CLIENT: PETE & SUZANNE EVANS
 PROJECT: RESIDENCE
 ADDRESS/LOCATION: CHRISTIAN LIGHT ROAD, FUGUY-VARINA, NC, HARNETT COUNTY
 SHEET: 1 OF 8
 DATE: SEPTEMBER 1, 2021
 SHEET NAME: FRONT & RIGHT SIDE ELEVATIONS

APPROVED
 Limited building only review
 Permit holder responsible for full compliance with the code

RIGHT SIDE ELEVATION
 SCALE: 1/4"=1'-0"

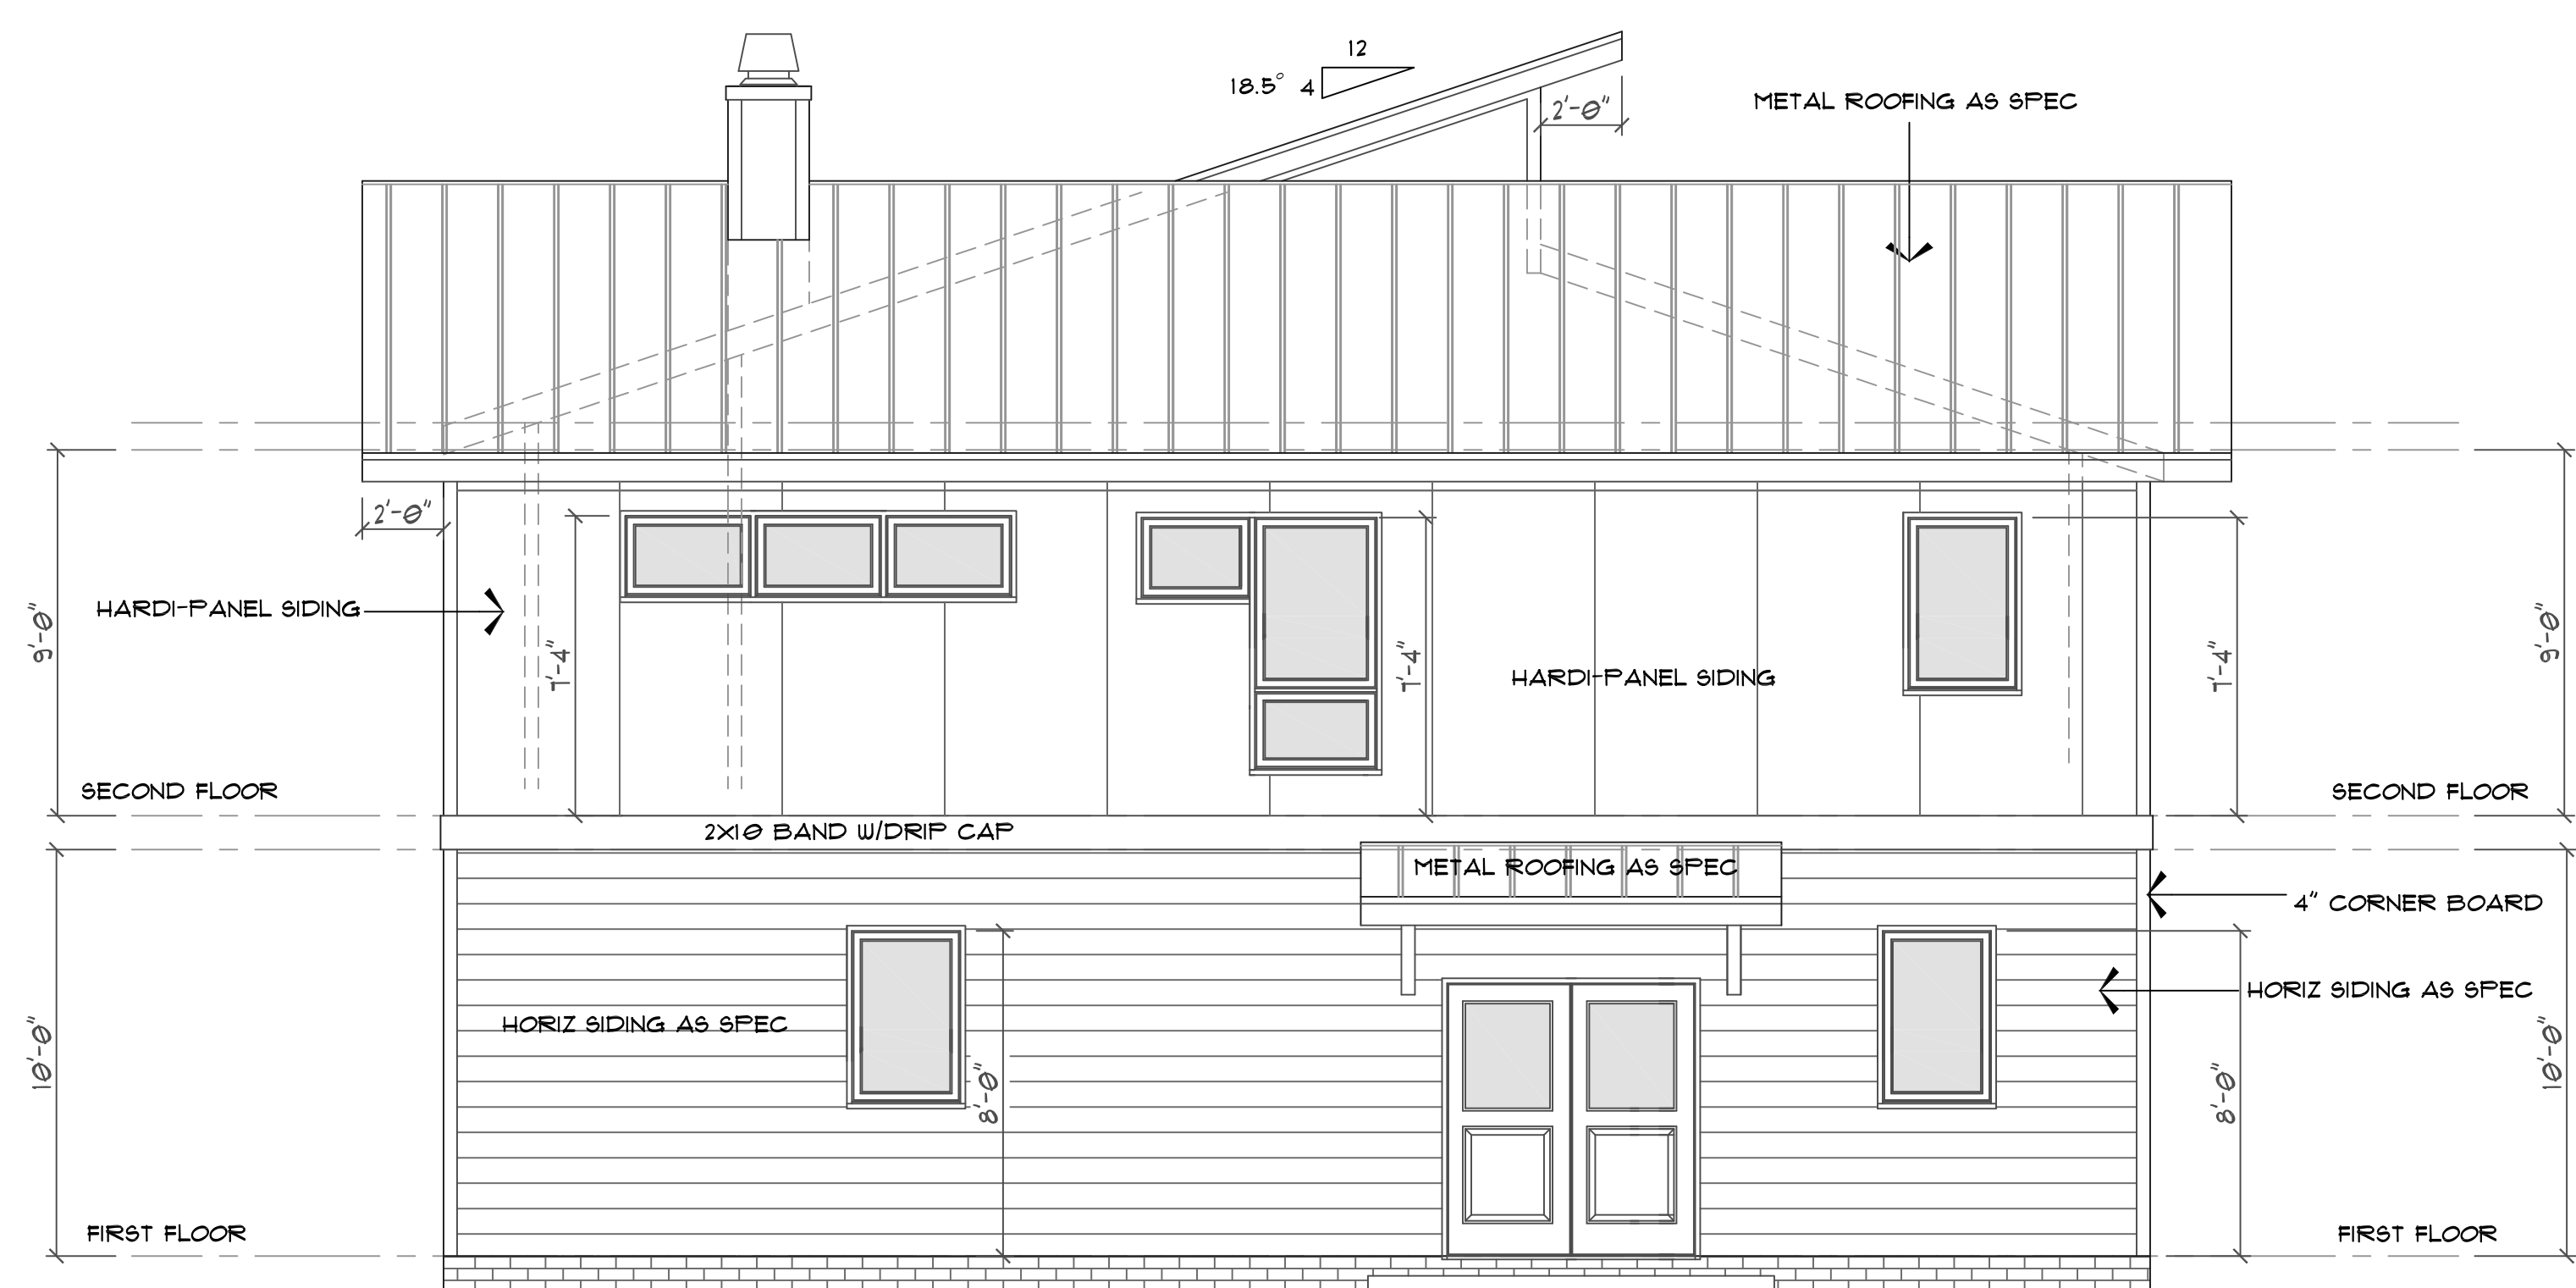
See notes on plan regarding casement window egress requirements

SECOND FLOOR PLAN

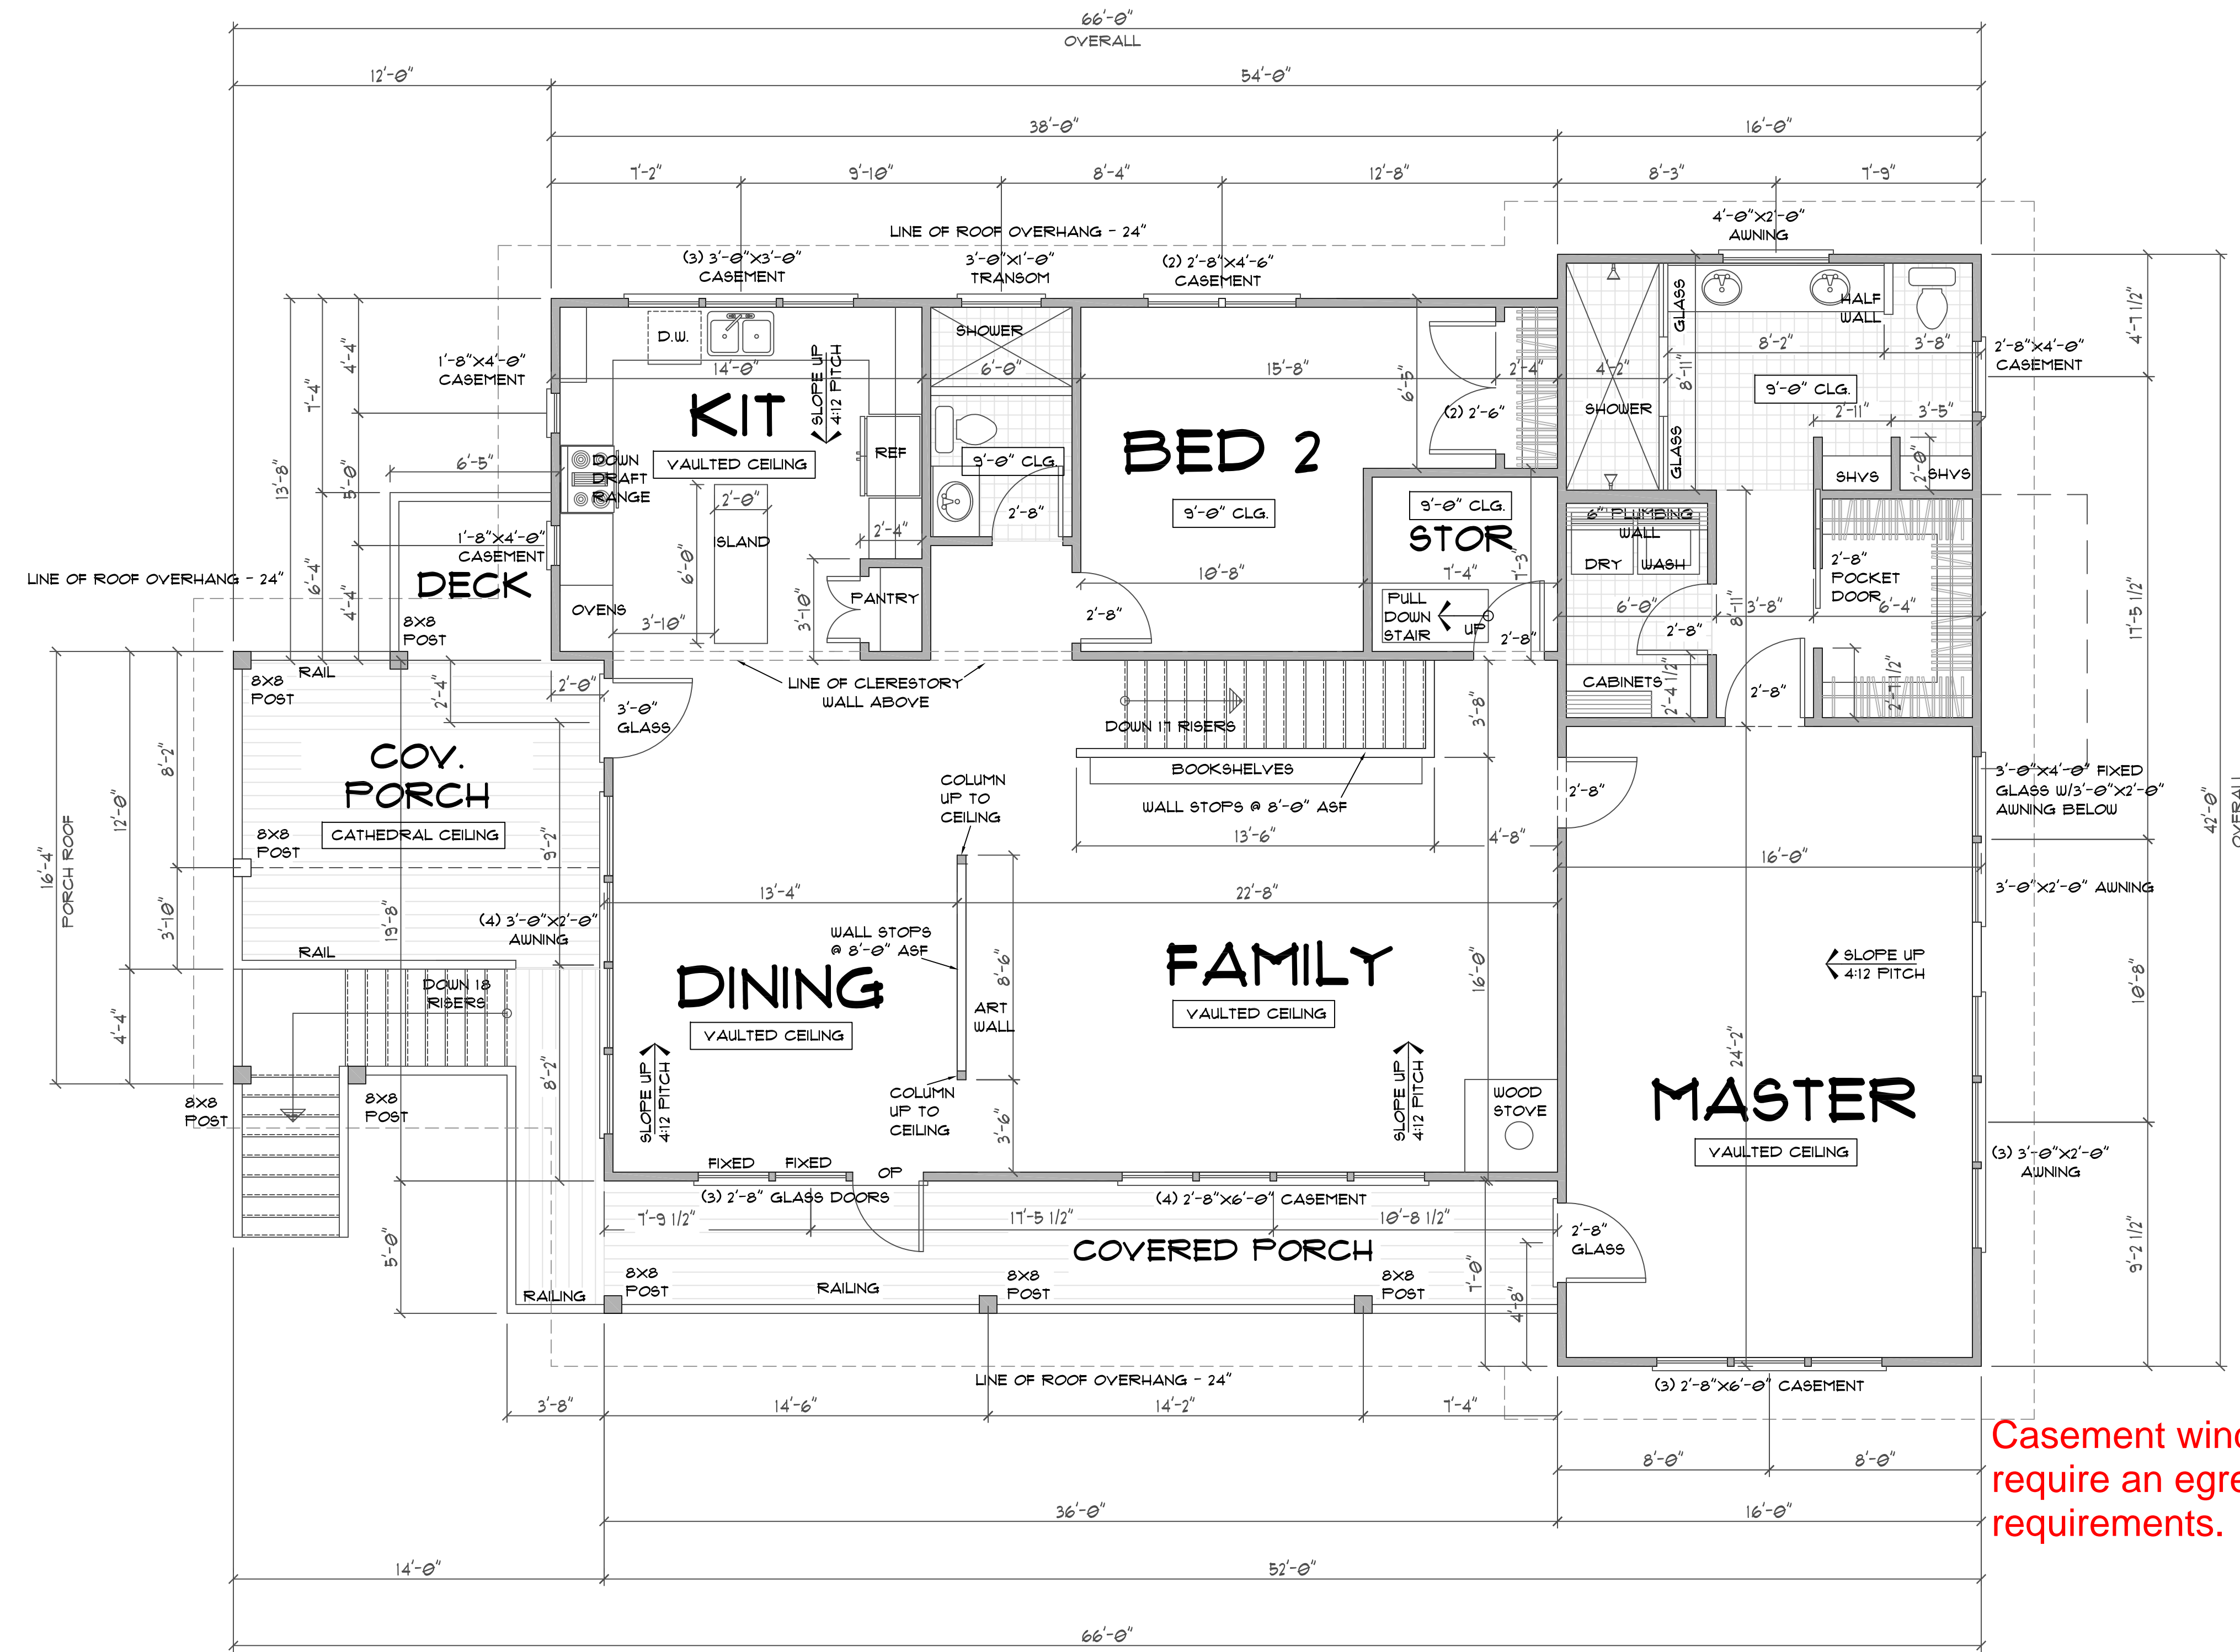
Casement windows in bedrooms will require an egress kit to meet code requirements.
